Town of Hilton Head Island Regular Design Review Board Meeting

DESIGN TEAM/DRB COMMENT SHEET

PROJECT NAME: Golf Academy – NEW DEVELOPMENT FINAL

DRB#: DRB-001268-2015

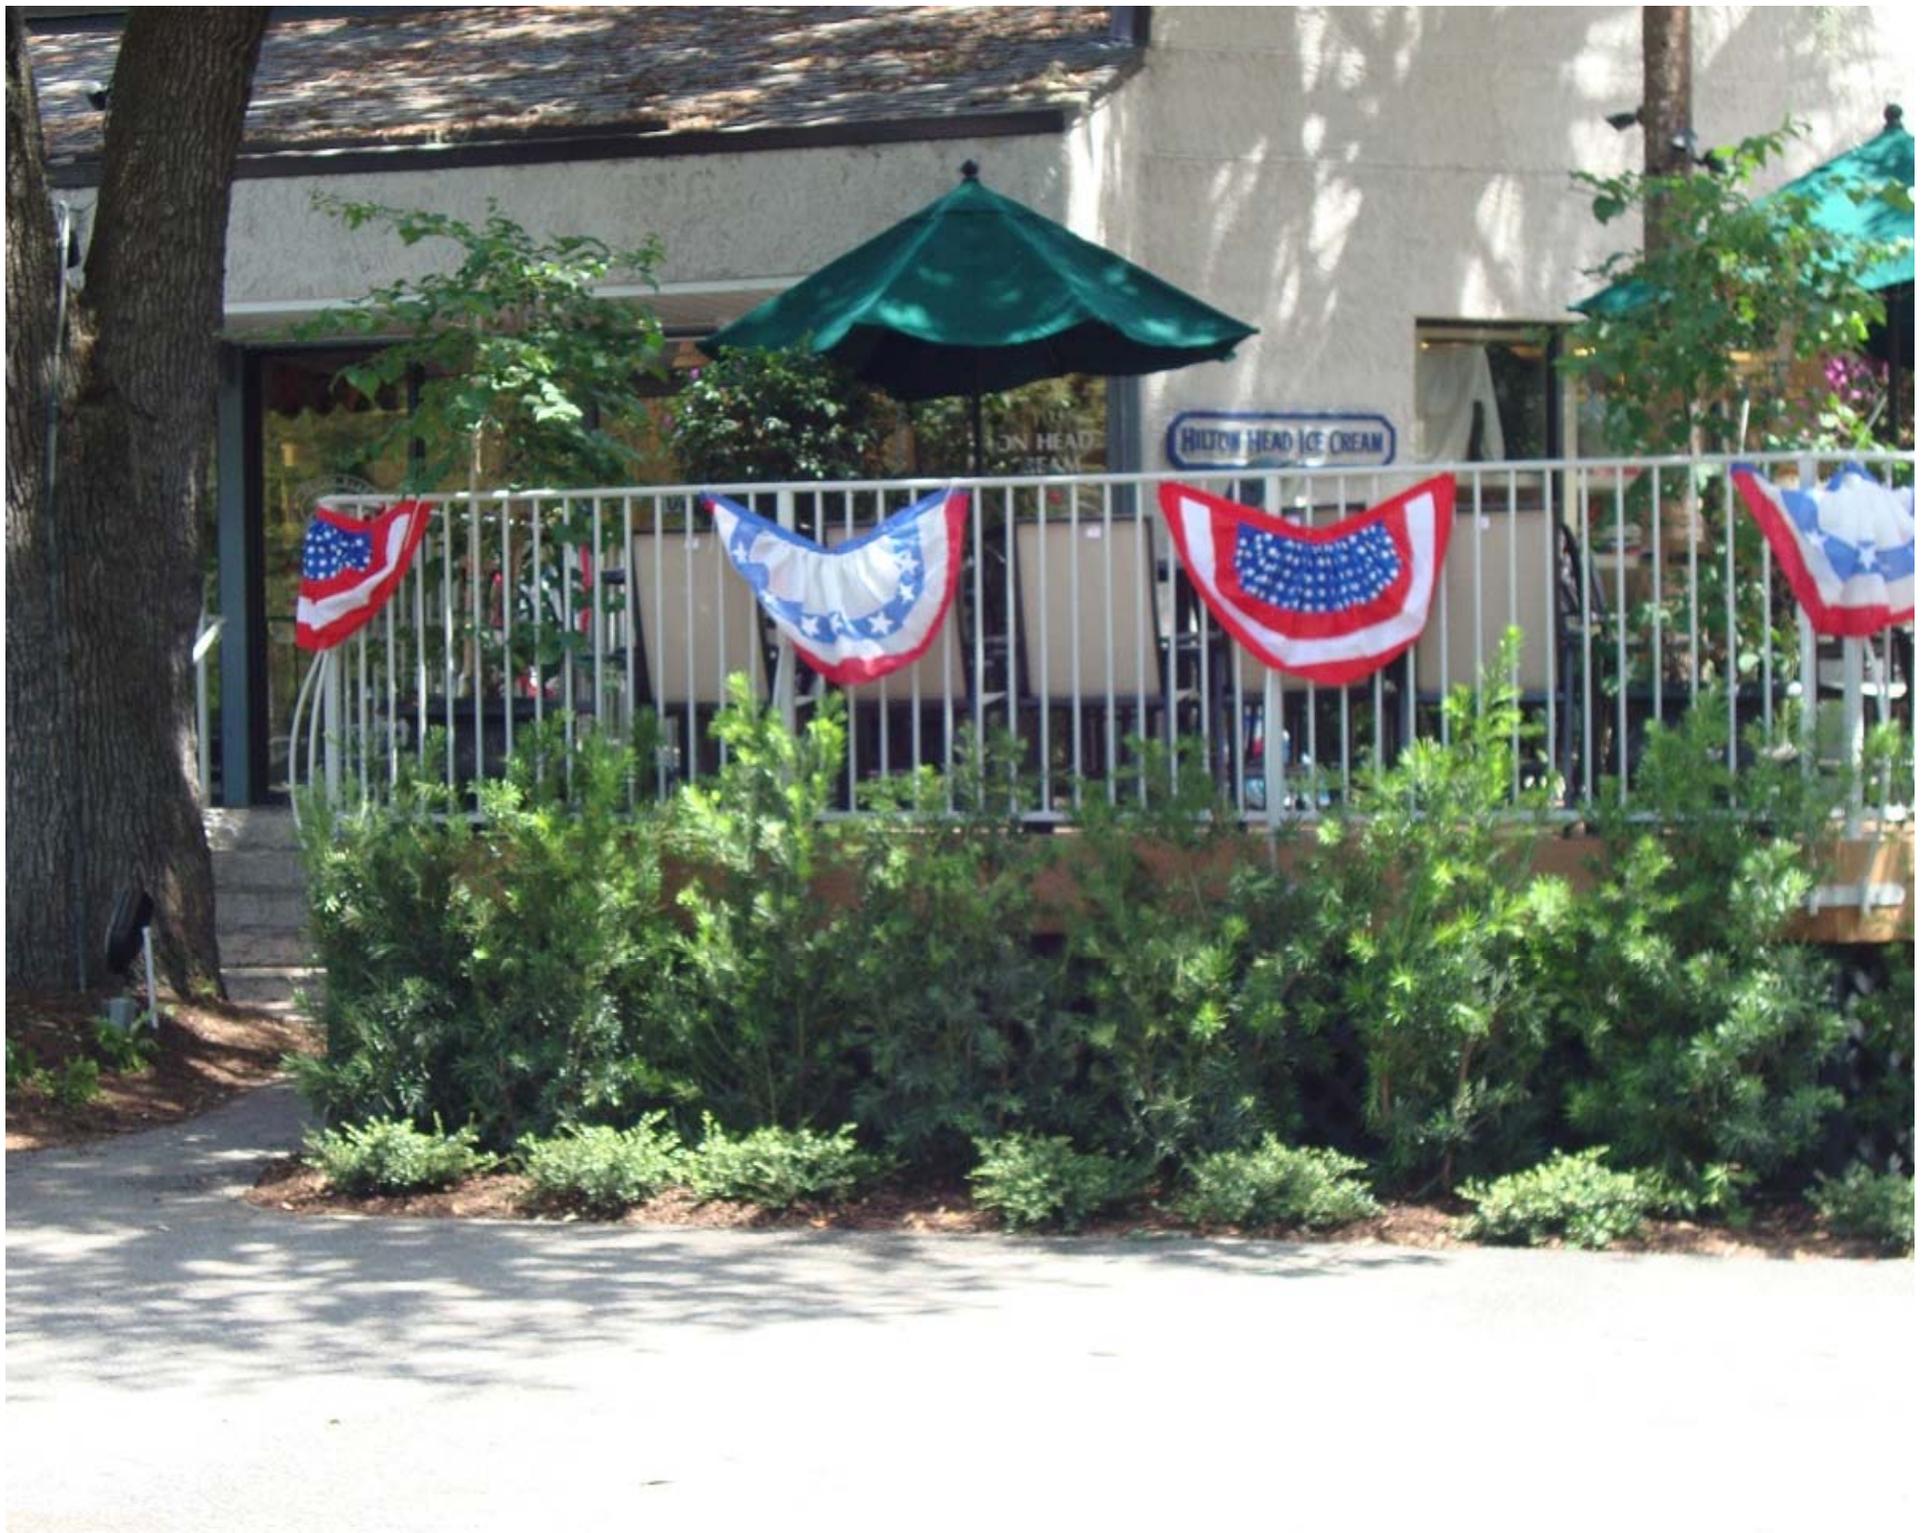
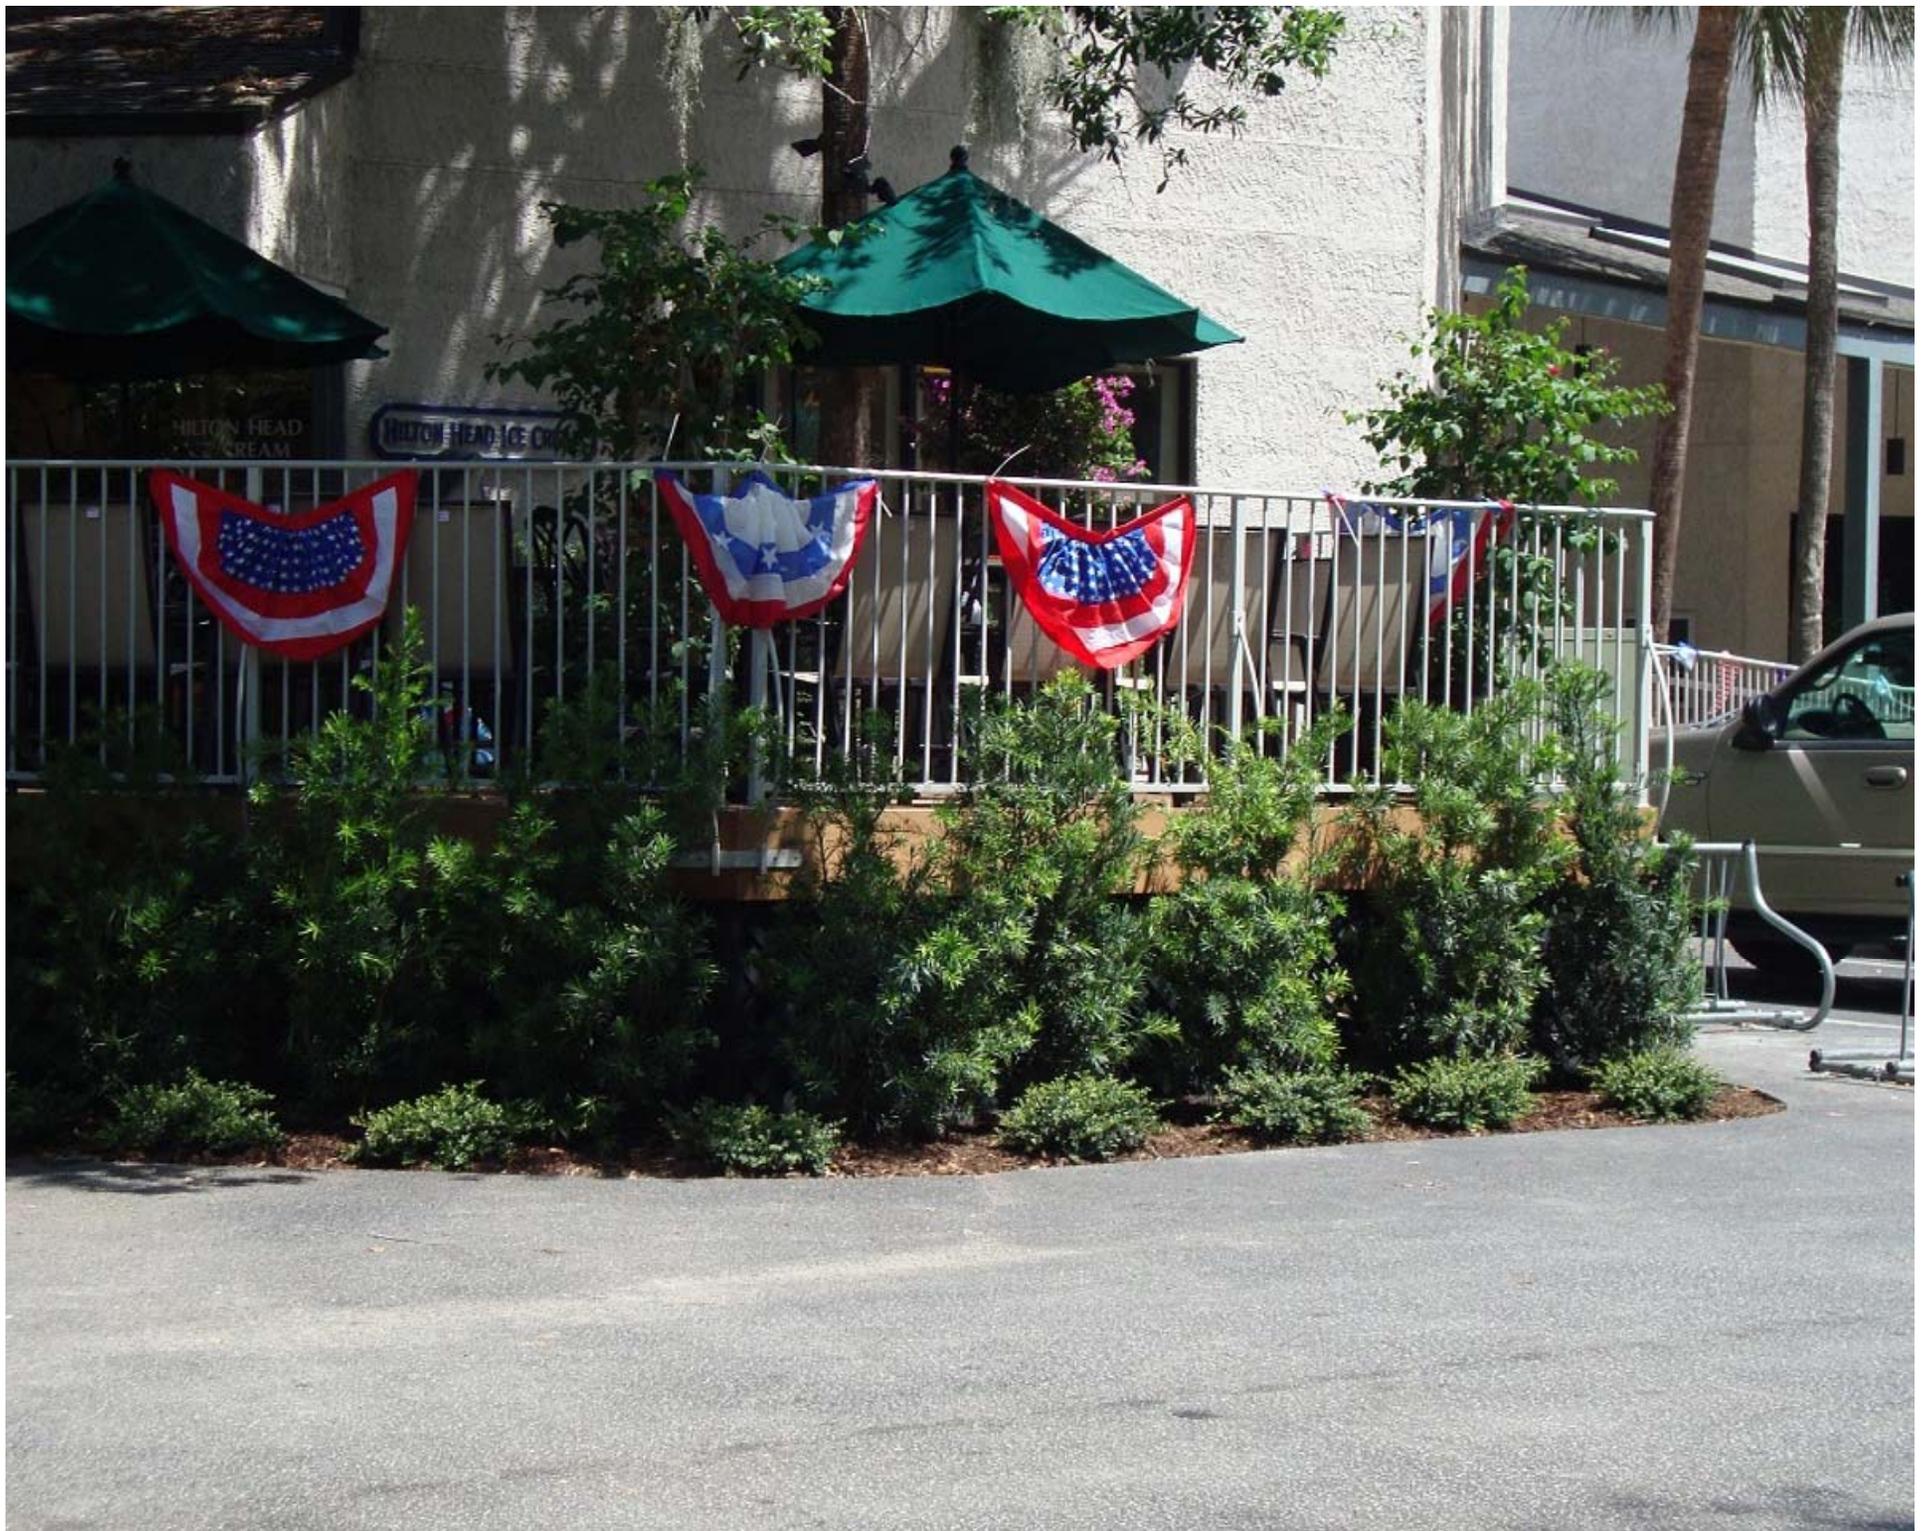
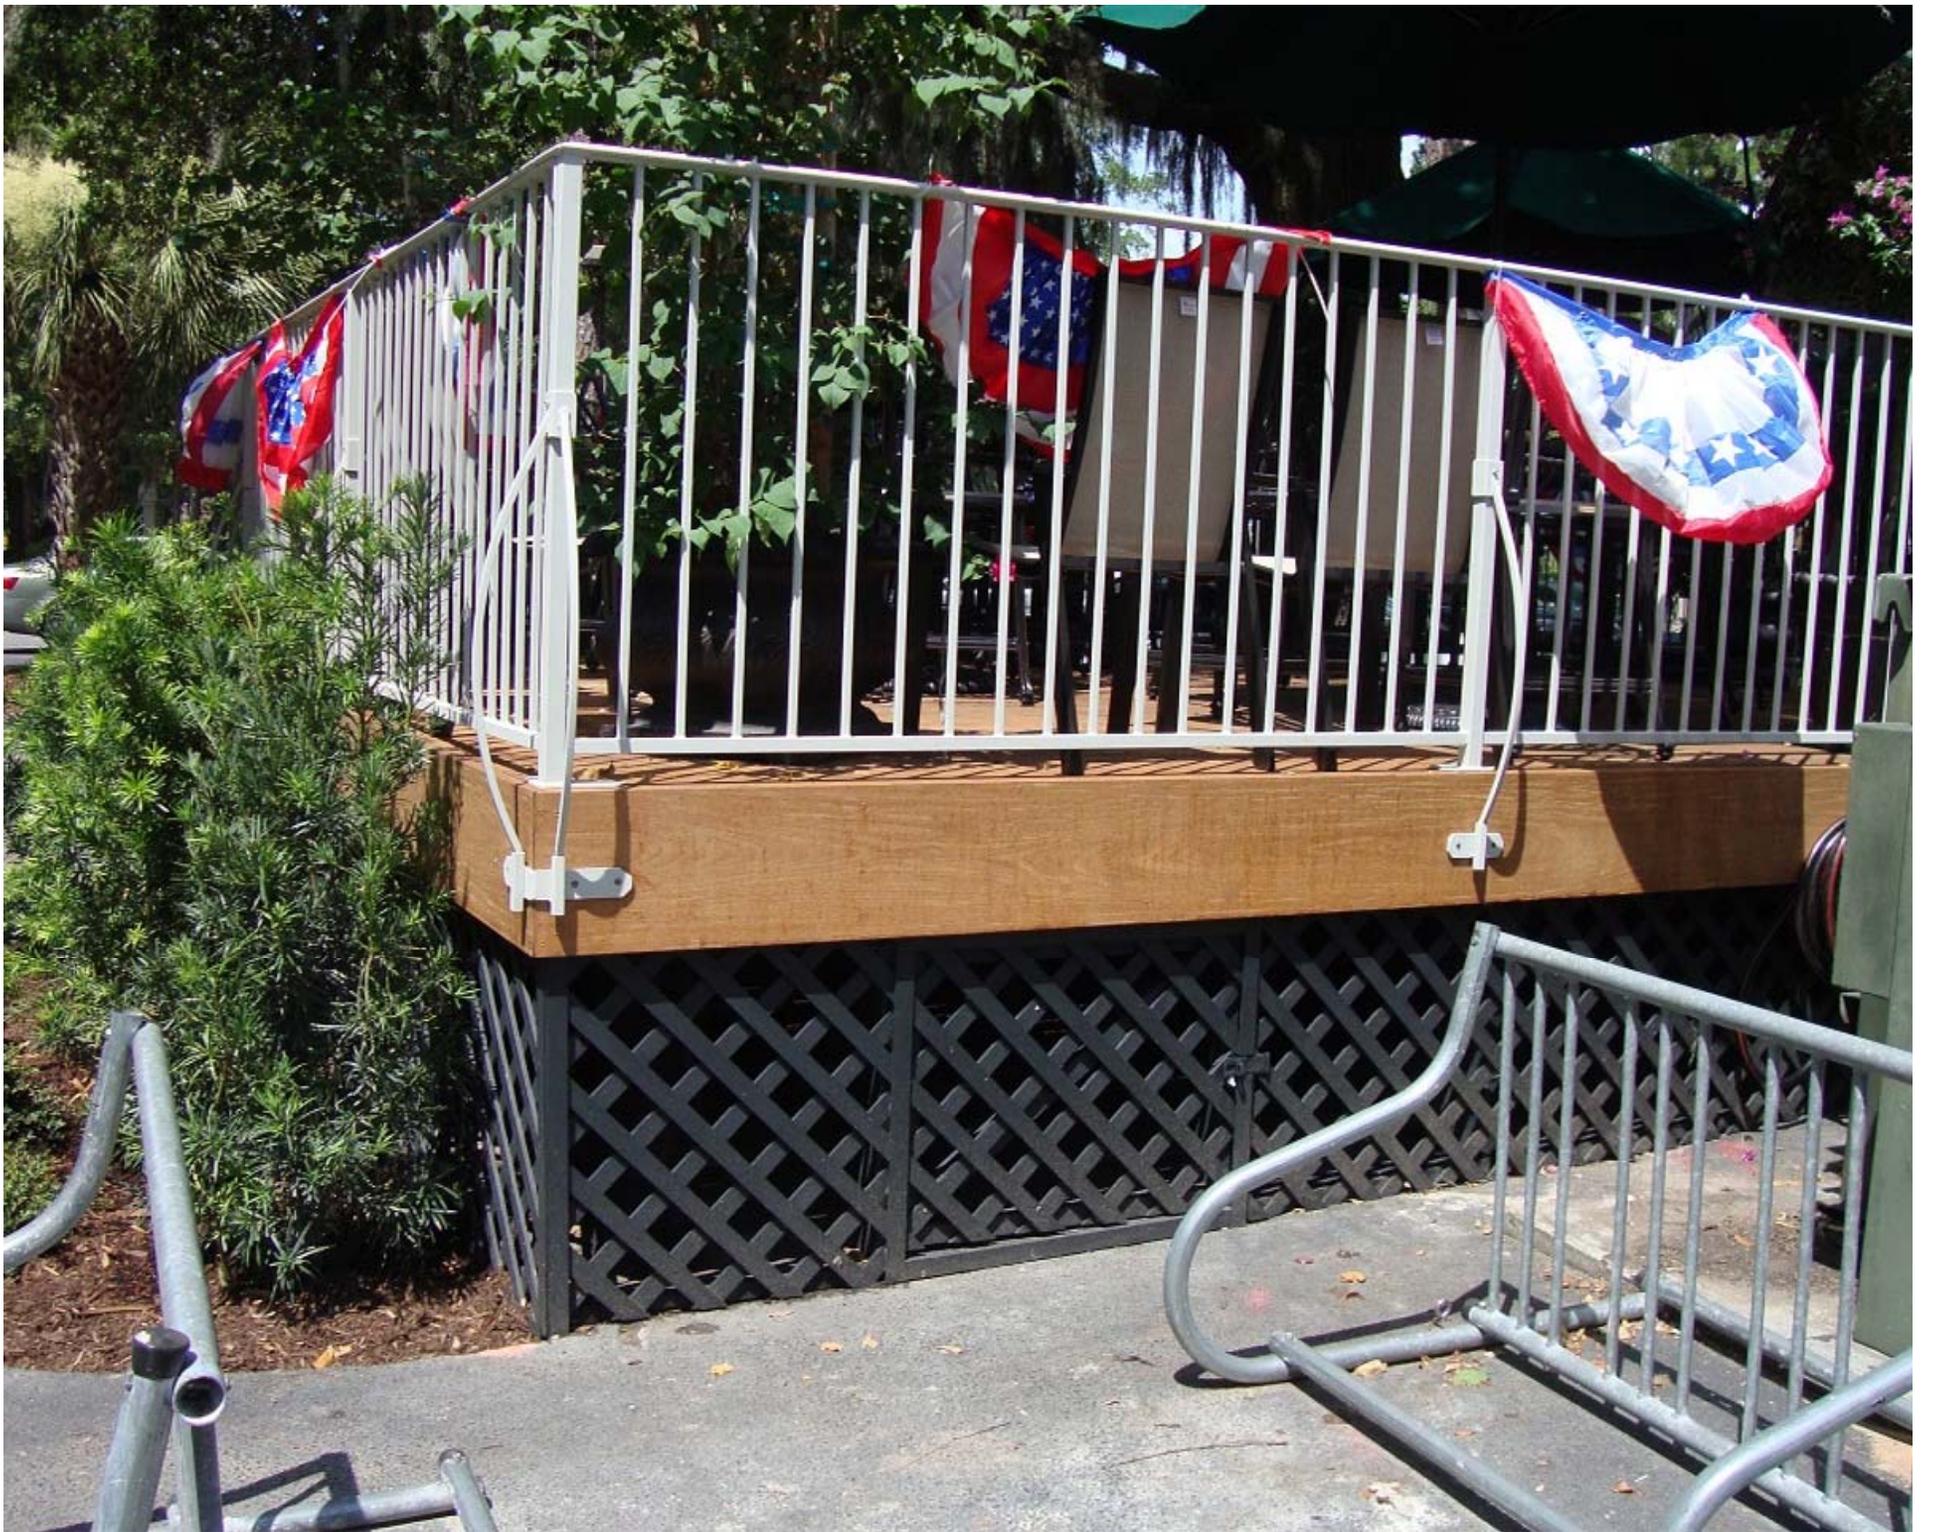
Enclosed are 3 photos of the finished deck, the Owner's requested we put lattice up to screen the underside of the deck for several reasons:

1. Fountain Center has a ferret cat issue and they do not want them to take up residence under the deck. This is a health hazard as well as a smell factor.
2. They want to prevent children from crawling under the deck as the south side adjoining the Live Oak tree and north side cannot have plant screening.
3. Lattice is found on site as a HVAC screen, the use of lattice permits the owner to still see under the deck to check for debris and will allow vines to grow over the lattice to create a greener space.

SITE DATA: JPGA TRAINING FACILITY

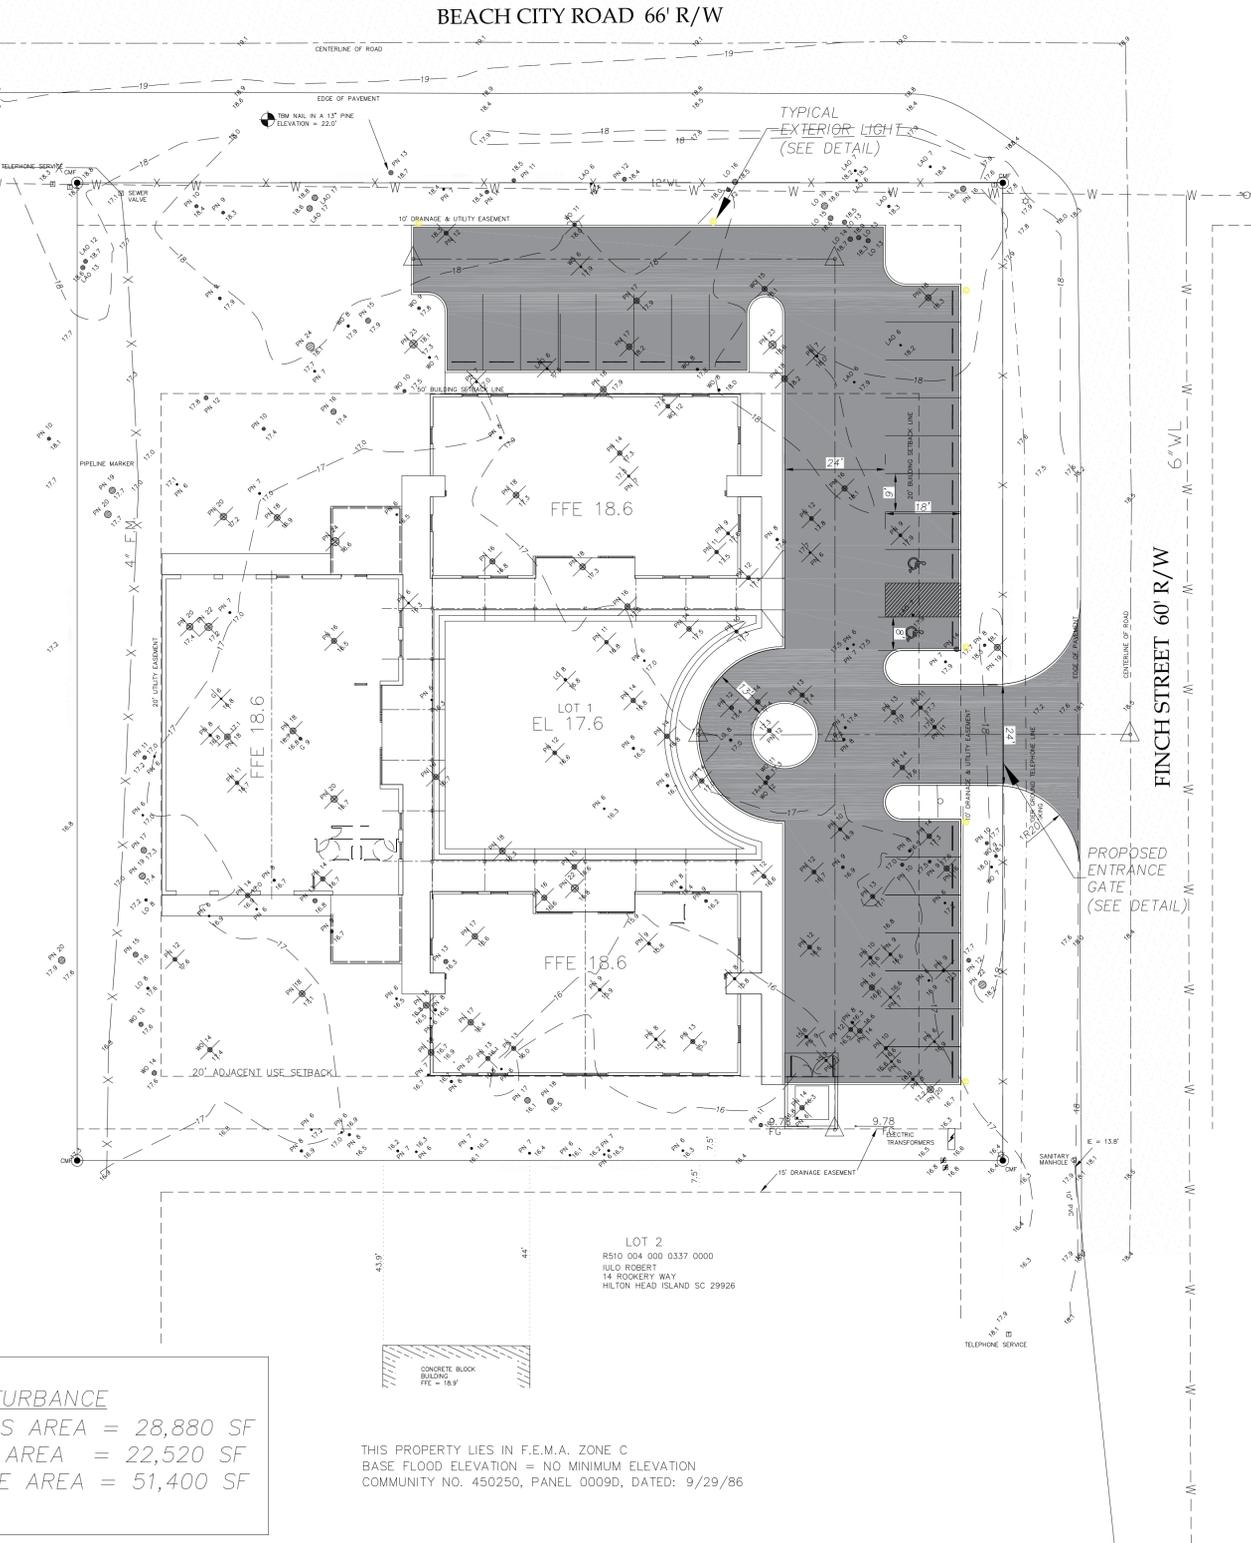
Bicycle parking and Electric Vehicle Charging Station are not shown on site plan.
